RE: 413 Harvard Drive SE (File: K16D083)
Grading and Drainage Plan
Engineer's Stamp Date – 10/19/15

A PROPOSED
GRADING AND DRAINAGE PLAN
FOR RESIDENTIAL UNITS AT
413 HARVARD DRIVE S.E.
ALBUQUERQUE, NEW MEXICO
OCTOBER, 2015

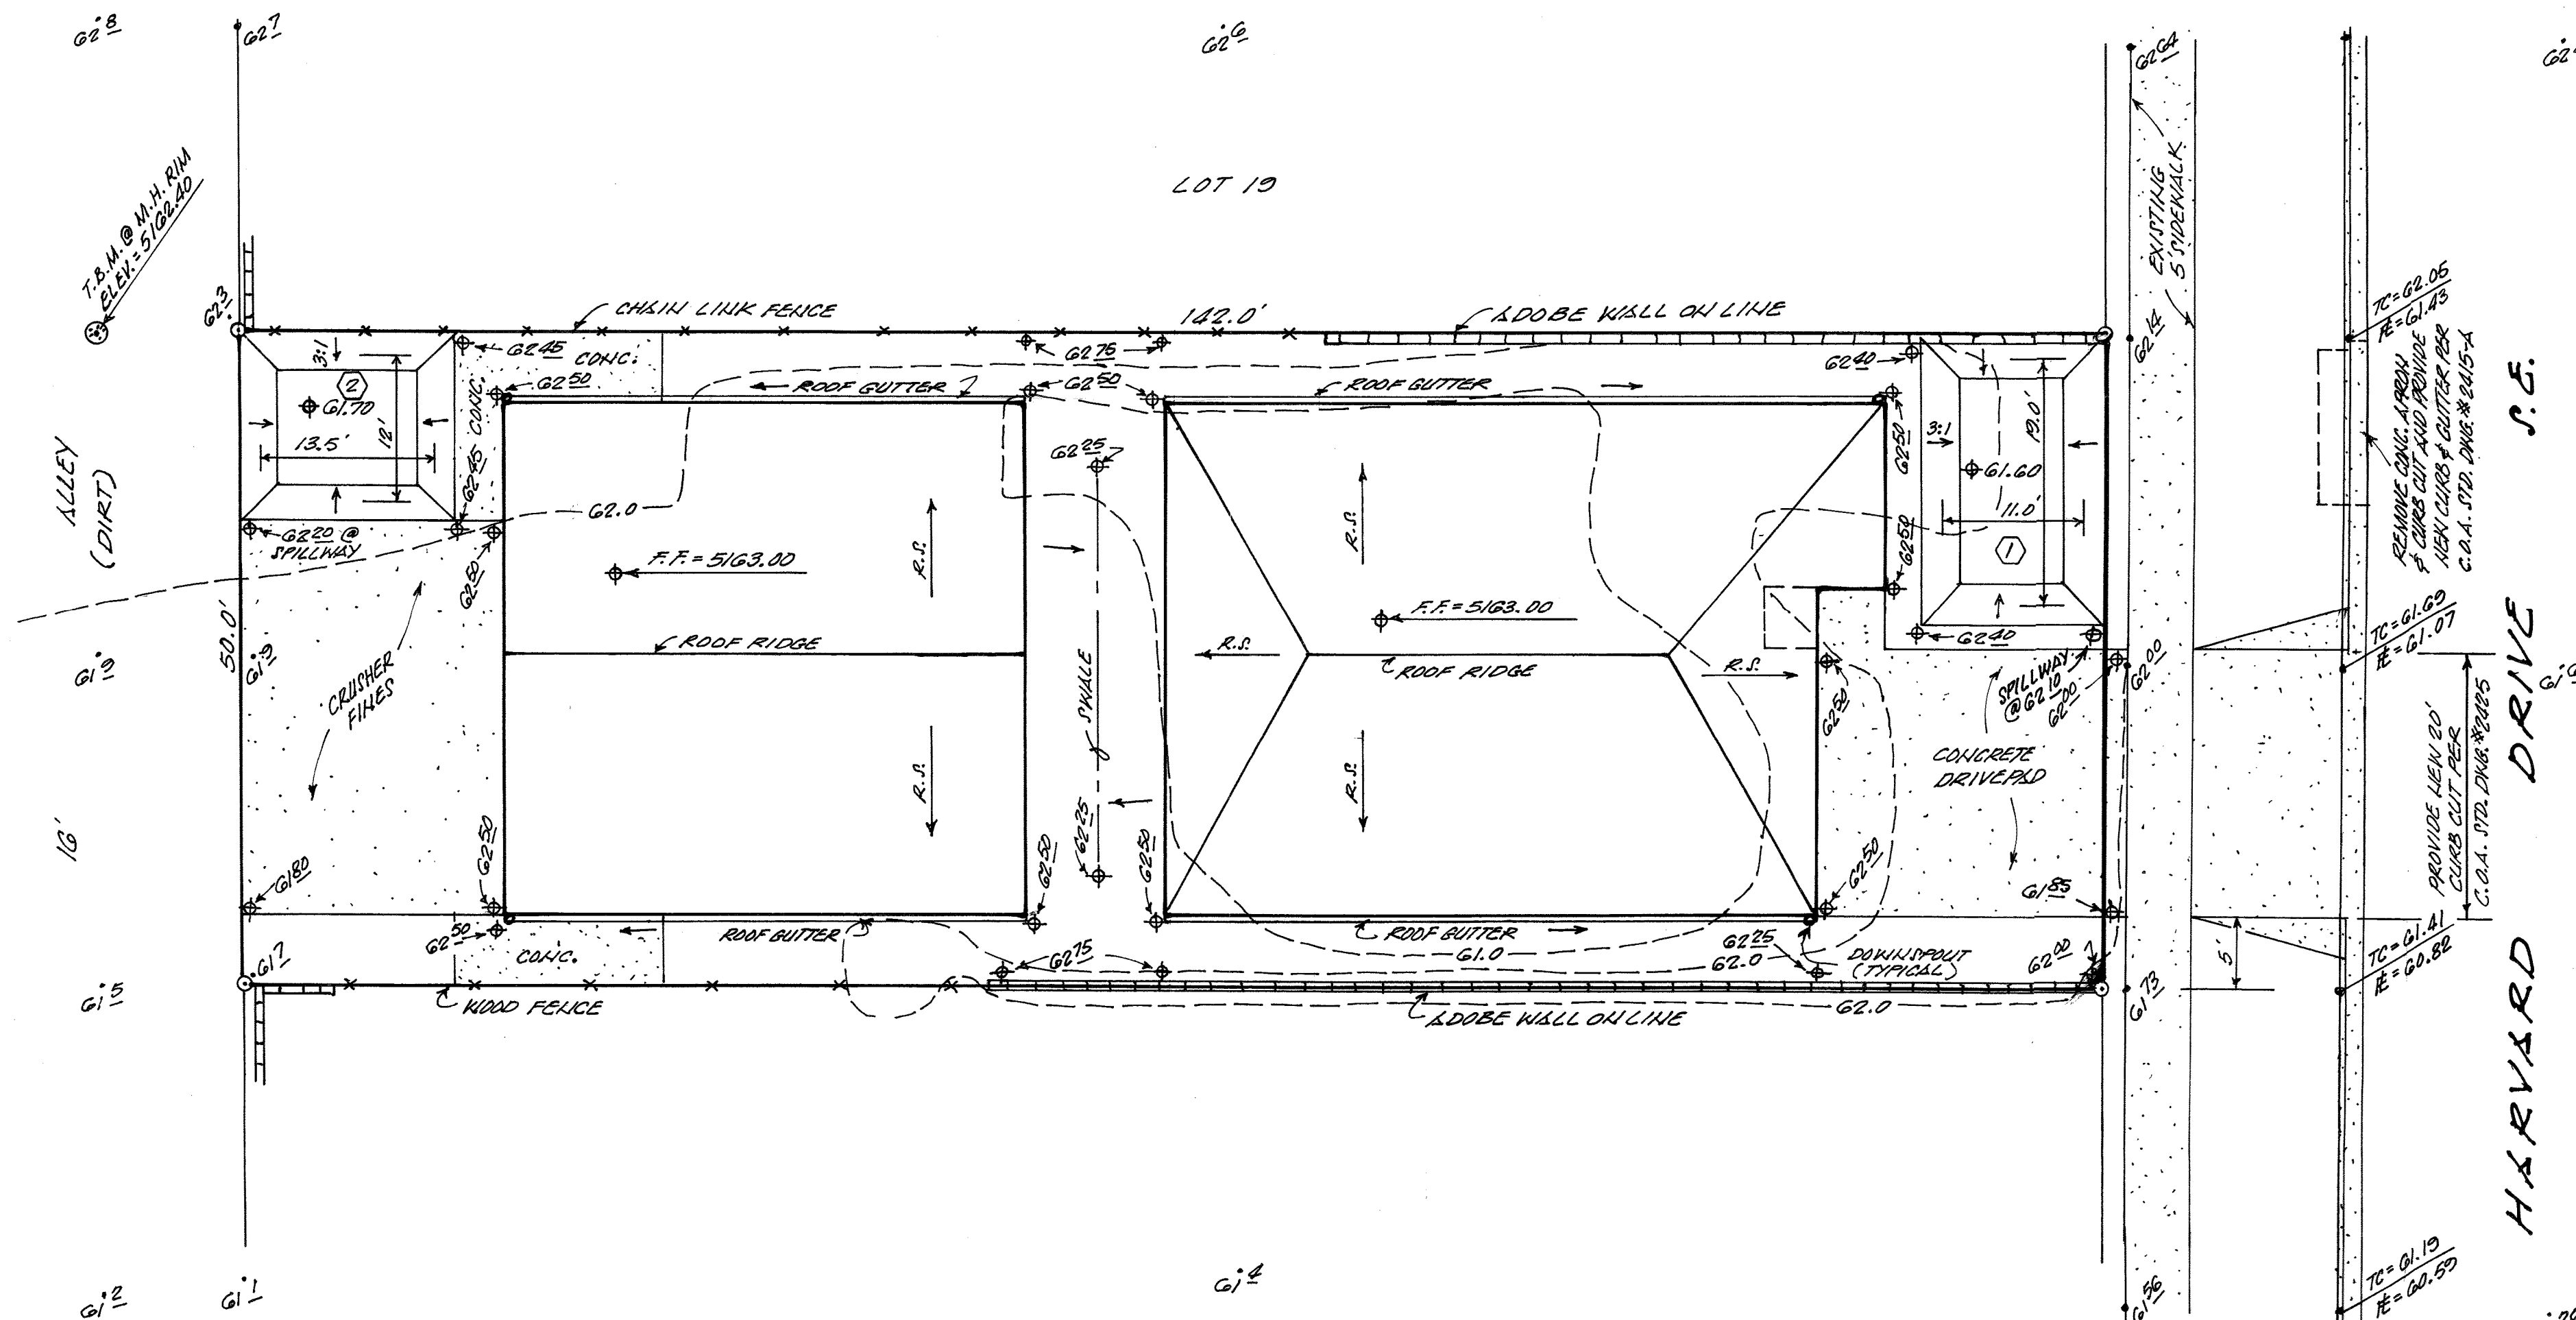
- Provide offsite discharge flows to the alley west of the property and to Harvard Dr. east of the property. Drainage patterns for both the alley and Harvard Dr. appear to flow south. Ensure that offsite flows can be captured by downstream inlets and that no properties are adversely affected by discharged flows.
- Provide documentation allowing flows to enter alley west of the property.
- Provide adequate detailed information on the Grading Plan to ensuring no flows enter adjacent properties to the north and south.
- Show limits of concrete removal at the northeast property corner to accommodate First Flush Pond 1.
- Clearly identify and define property lines.
